## **Addendum 1 for RFB 948200-01**

Project Name: IDB Chiller Replacement

Iowa Department of the Blind  
Chiller Replacement  
Addendum #1  
February 6, 2025

1. ME200 – BOILER ROOM PLAN - MECHANICAL/ELECTRICAL:
  - a. **MODIFY** Electrical Keyed Notes as shown.
  - b. **ADD** notes to drawing as shown.
  - c. **ADD** notes to CHILLER REFRIGERANT PURGE CONTROL DETAIL as shown.
  - d. **MODIFY** CHILLER and EXHAUST FAN SCHEDULES as shown.
  - e. **MODIFY** WATER COOLED CHILLER DETAIL and ROOF FAN MOUNTING DETAIL as shown.
  - f. Refer to attached full size sheet ME200.

3 EXISTING MAU SUPPLY DUCT  
NOT TO SCALE

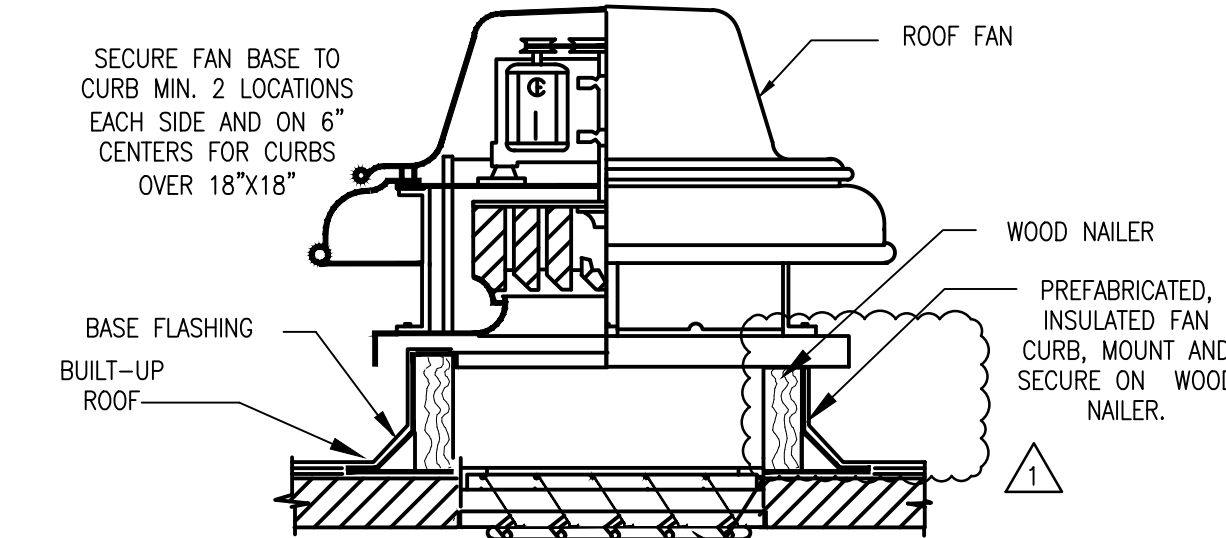
CUT IN 12X18 OPENING HERE AND ADD INSULATED DAMPER FOR REFRIGERANT PURGE MAKEUP AIR.
